**PARK CITY PLANNING DEPARTMENT ADMINISTRATIVE PUBLIC HEARING MEETING  
SUMMIT COUNTY, UTAH**

**475 Woodside Avenue – Historic District Design Review** – The Applicant Seeks to Demolish an Existing Single-Family Dwelling and Construct a New Single-Family Dwelling on a Steep Slope in the Historic Residential - 1 (HR-1) District. PL-22-05311

# Planning Department Staff Report

**Subject:** 475 Woodside Avenue  
**Application:** PL-22-05311  
**Author:** Caitlyn Tubbs,  
Sr. Historic Preservation Planner  
**Date:** April 20, 2023  
**Type of Item:** Historic District Design Review (HDDR)

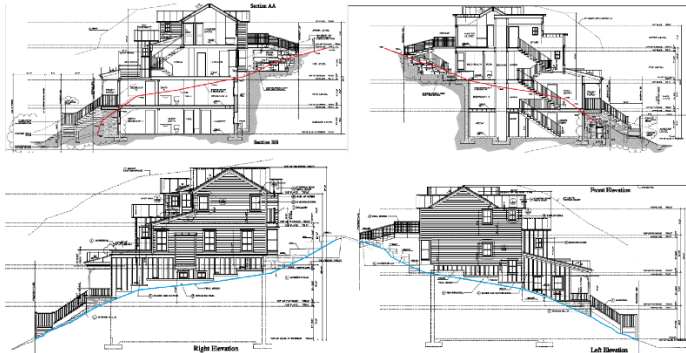
Criteria	Analysis of Proposal
<b>LOCATION OF DEVELOPMENT</b> – development is located and designed to reduce visual and environmental impacts of the Structure.	<b>Complies</b> – The proposed SFD is sited two feet closer to the Front Lot Line (12' setback) than the Existing Dwelling (14' setback) and is compatible with the siting of neighboring Structures. The proposed SFD will face Woodside Avenue and provide a front entrance along the same street. A set of existing retaining walls (built to the Front Lot Line) will be removed and will no longer interrupt the Streetscape.

Streetscape Elevation

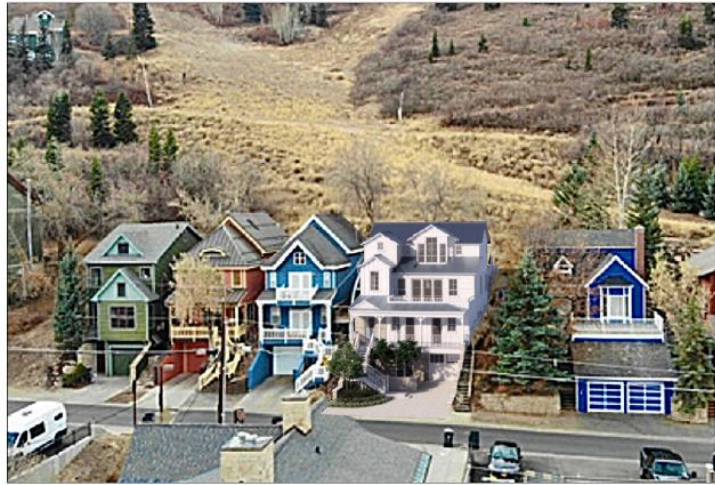
<p><b>DWELLING VOLUME</b> – The maximum volume of any Structure is a function of the Lot size, Building Height, Setbacks, and provisions set forth in this Chapter. The Planning Director may further limit the volume of a proposed Structure to minimize its visual mass and/or to mitigate differences in scale between a proposed Structure and existing Structures.</p>	<p><b>Complies</b> - The proposed SFD is comparable in height and massing with other Structures along the same block face. The upper levels of the SFD step back from the street to reduce the visual impact of the Structure from the Street, which is a common feature on neighboring buildings as well. A reduction in height is not necessary to mitigate differences in height or scale.</p>
<p><b>BUILDING HEIGHT   STEEP SLOPE</b> – The HR-1 Zoning District Height is 27 feet. The</p>	<p><b>Complies</b> – The proposed SFD is comparable in height and massing with other Structures along the same block face. The upper levels of the SFD step</p>

Planning Director may require a reduction in Building Height for all or portions of a proposed Structure to minimize its visual mass and/or to mitigate differences in scale between a proposed Structure and the Historic character of the neighborhood's existing residential Structures.

back from the street to reduce the visual impact of the Structure from the Street, which is a common feature on neighboring buildings as well. A reduction in height is not necessary to mitigate differences in height or scale.
